DEVELOPMENT REVIEW BOARD REPORT

MEETING DATE: June 17, 2004

22-DR-2002#2
Scottsdale East Plaza

Request remodel existing shopping center and construct new building.

SHEET NUMBER
C-1

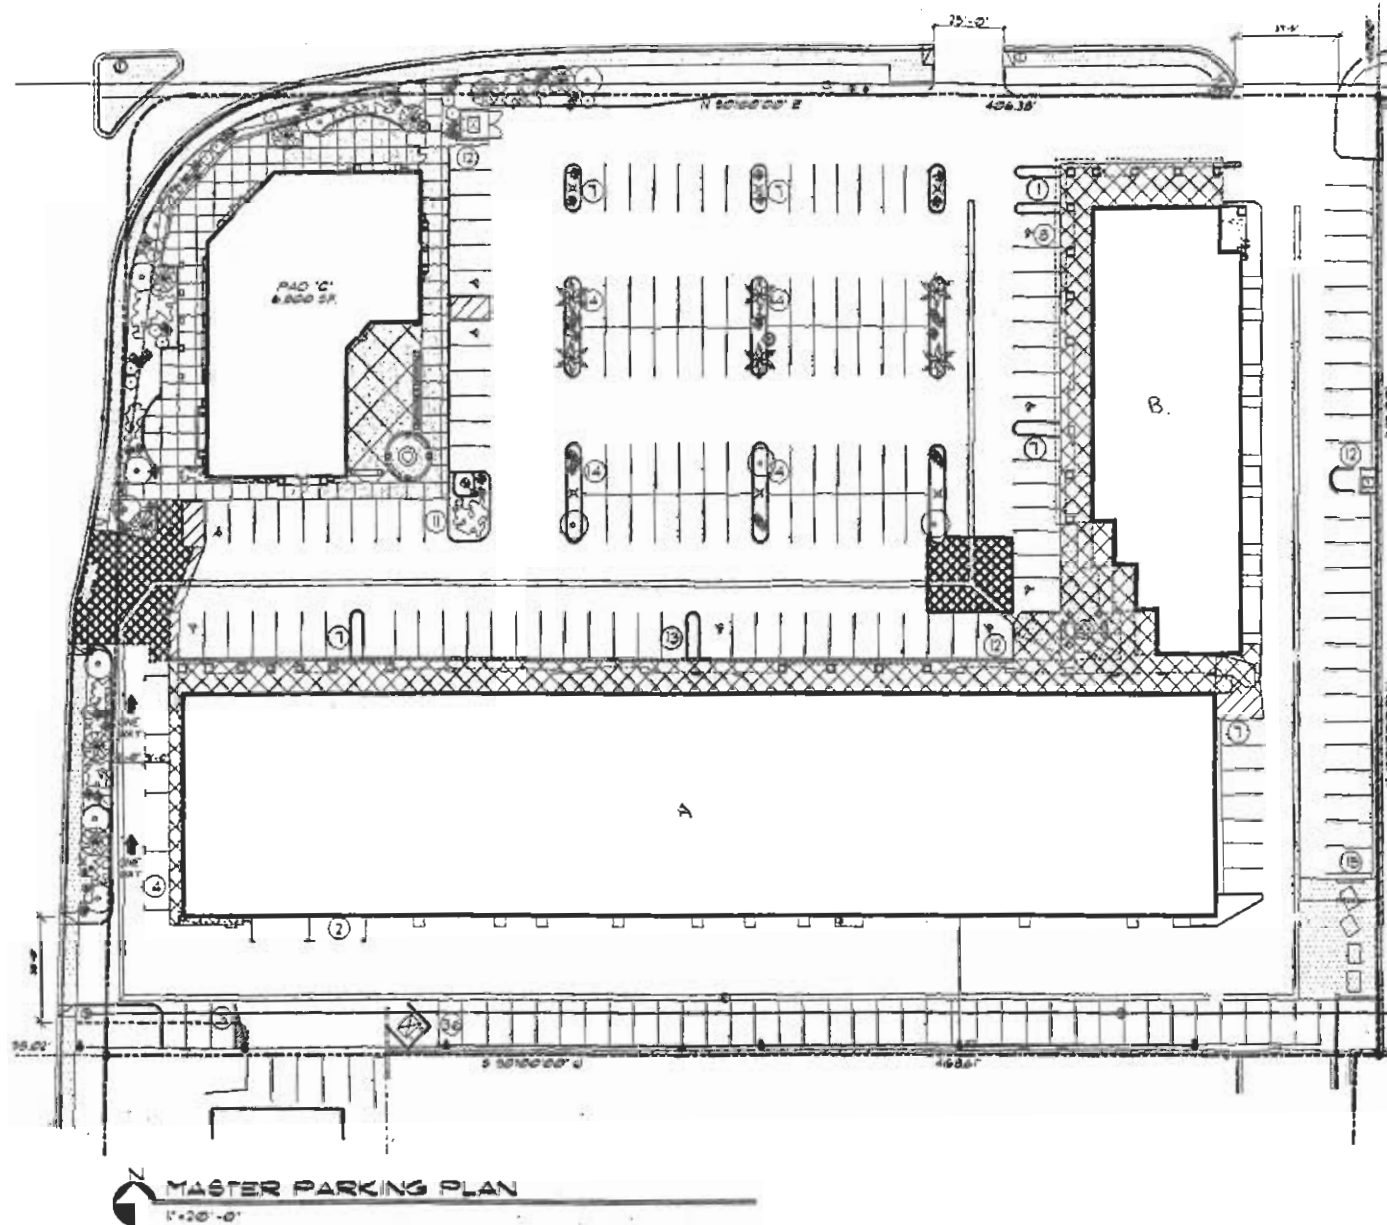
3. Trees shall be provided as noted on the landscape plan [label L-1](#) proposed at Development Review Board (15 gallon minimum, 23 trees minimum) of which 50% shall be mature as defined in Article III of the Zoning Ordinance or larger.

4. *With the final plan submittal, the developer shall revise the landscape plan to indicate which trees are mature, to the satisfaction of Plan Review and Permit Services staff.*

5. Provide low water consumptive plant materials.
6. With the final plan submittal, the developer shall replace the trachycarpus wagnerianus species with a palm tree species from the Department of Water Resources (DWR) low water plant list for the Phoenix Active Management Area (AMA), or another type of tree from the DWR list, to the satisfaction of Plan Review and Permit Services staff.

13. All rights-of-way adjacent to this property shall be landscaped and maintained by the property owner.
14. Parking lot landscape islands be modified to delete palm trees and add shade trees with type and size being subject to staff approval.
